Our ref: HLEF85532 – Cottered Solar Farm

Date: 6th May 2025

LLFA Comments Response Technical Note – 3/21/2245/FUL – Land to the west of the A507 between Cottered and Cromer, Hertfordshire, SG9 9PU

Title **Conceptual Drainage Strategy
Sheet 1**

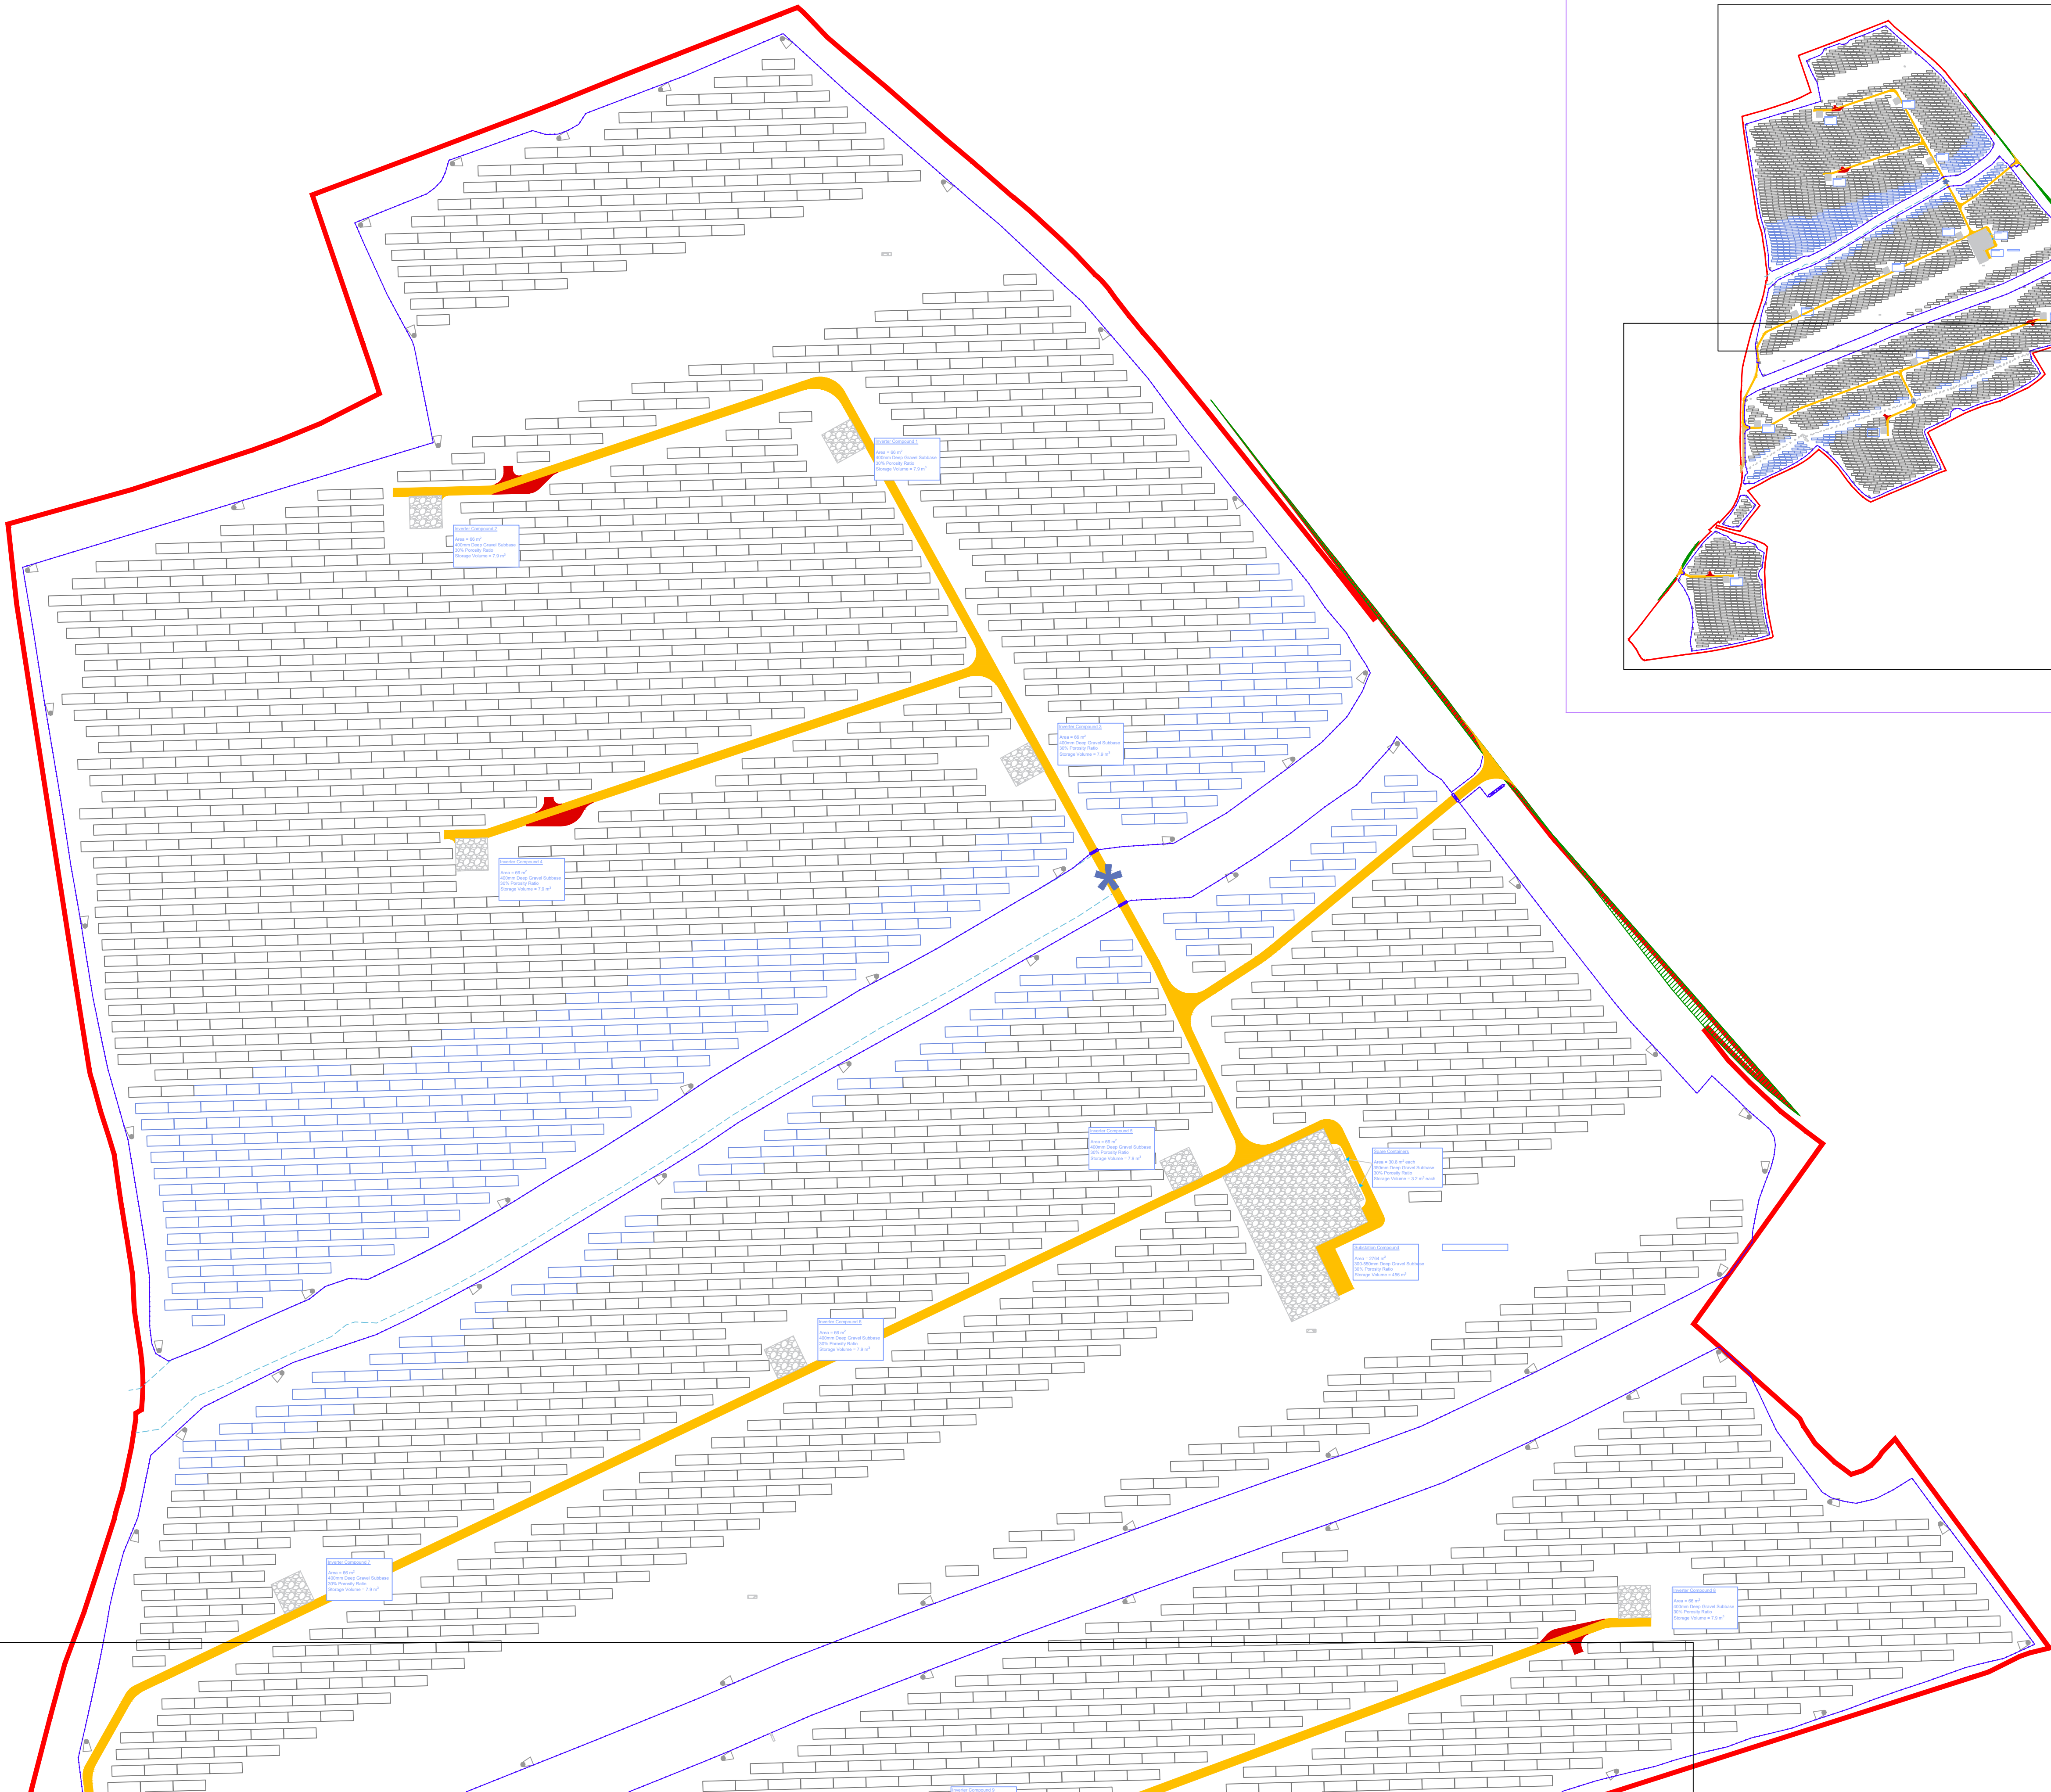
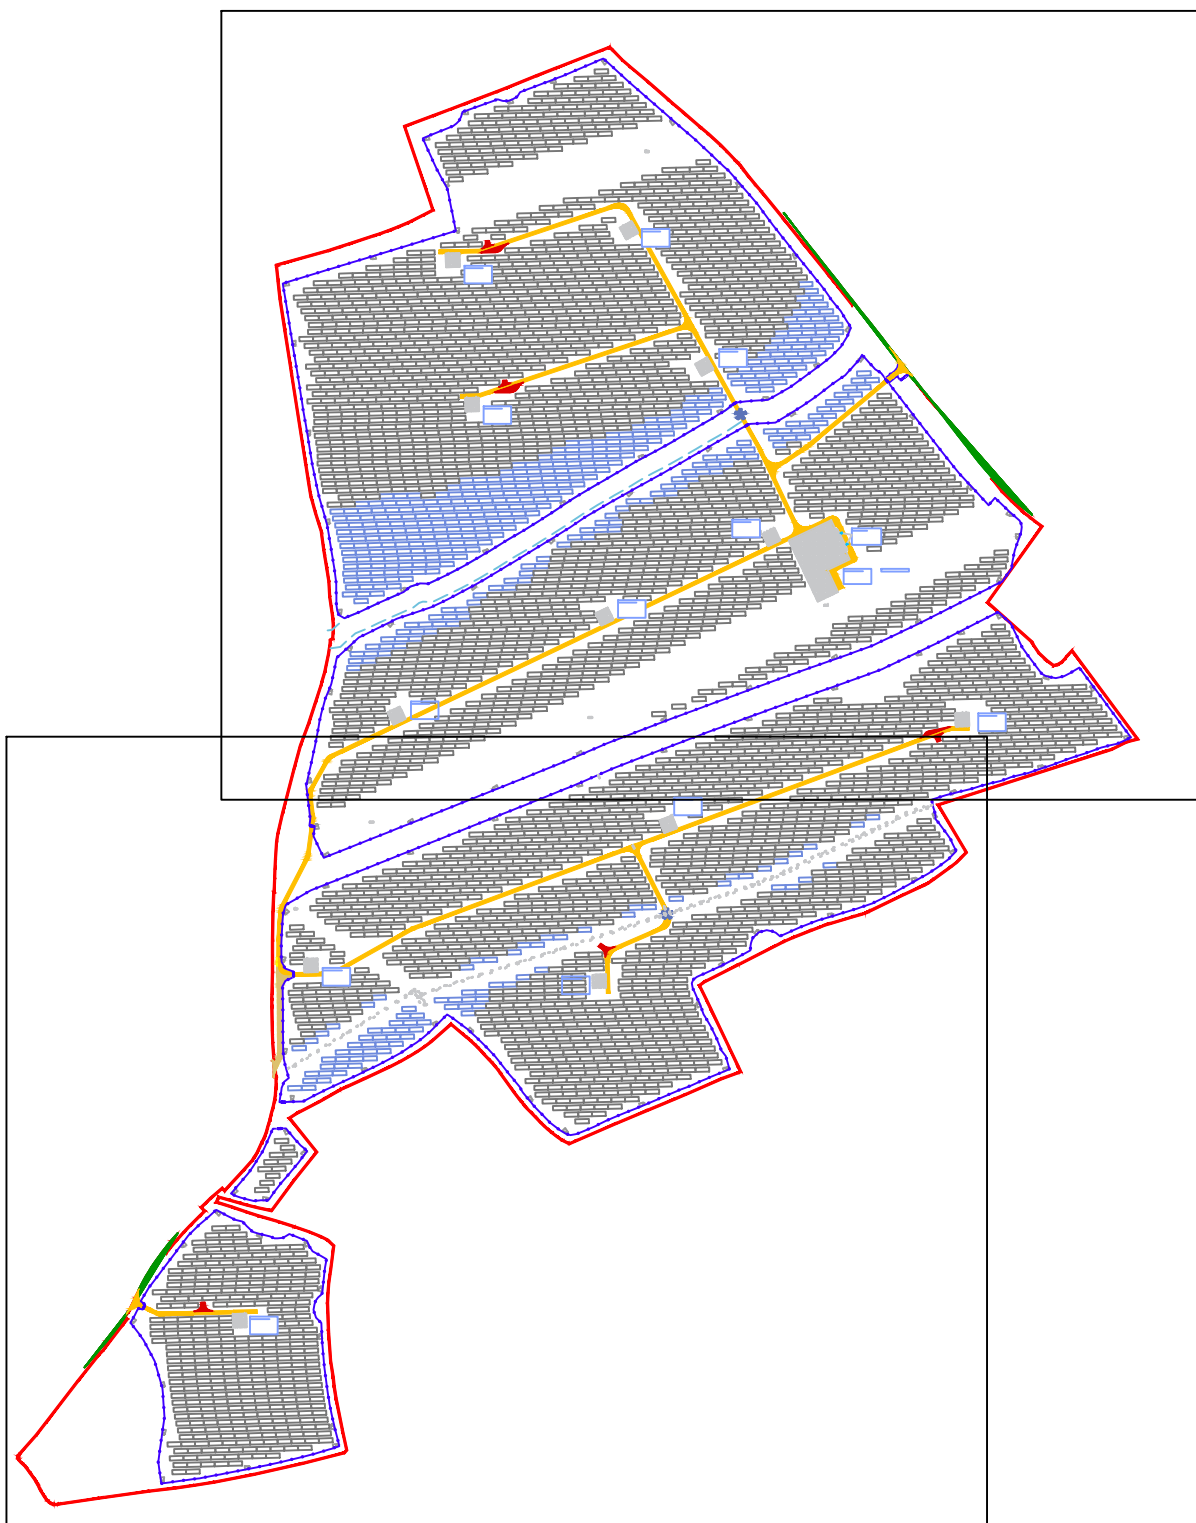
- *Layout and/or drainage layout drawings need to show all the drainage features (storage and conveyance), with labels the same as those in the submitted supporting calculations. Confirmation of any formal drainage on site is required in a drawing. Currently, it is unclear as to whether formal drainage will be used on site.*

- *Drawings of cross sections and long sections of all the network and structures such as ponds, basins and swales need to be supplied. Confirmation of any formal drainage on site is required in a drawing. Currently, it is unclear as to whether formal drainage will be used on site.*

Conceptual Drainage Layout Drawing

No formal drainage is proposed for the solar farm panels elements of the proposed development. The drainage strategy is described in Section 10 of the FRA report. An illustrative drawing showing the proposed measures to address the increase of impermeable area due to installation of ancillary infrastructure is available in Annex D of this technical note.

- Cross sections of the gravel sub-bases will be provided at detailed design stage. It is proposed that details such as cross sections are secured by condition at the detailed design stage, once planning permission has been granted. This approach allows for the refinement of the drainage design while ensuring sufficient storage on site.
